MANDATORY SERVICE BULLETIN

Service Bulletin No.: DAC1-73-05 Rev 1

Title: Operating Limitations with Altitude
Compensating Fuel Systems

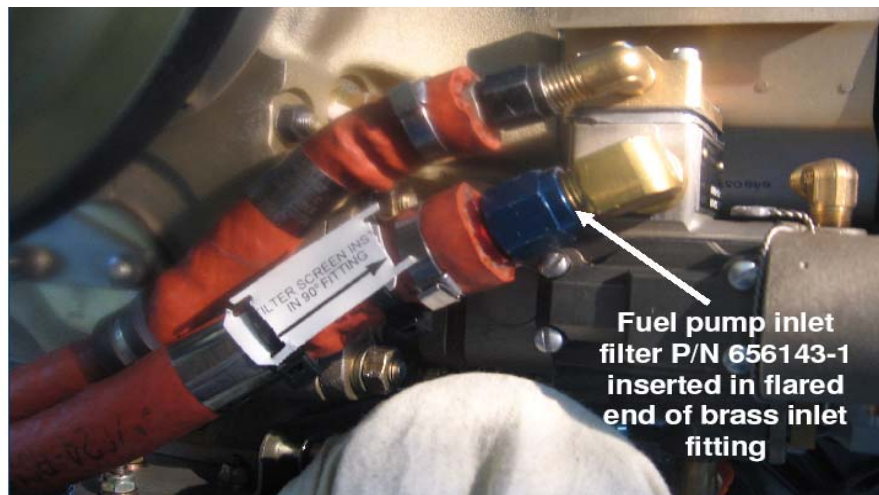
- 10.3** If the mechanical fuel pump (part number 649368-49A1, 649368-52A1, or 649368-54A1) has been replaced since delivery; remove mechanical fuel pump inlet hose to verify installation of filter element P/N 656143-1. If filter is installed, do not remove (see photo of installed filter). Inspect filter with a flashlight and mirror for contaminants. If clean, then reattach fuel line. If required, remove and clean filter. Reinstall filter and reattach fuel line.

- 10.3.1** If filter is not installed, install P/N 656143-1. Ref SIL05-6
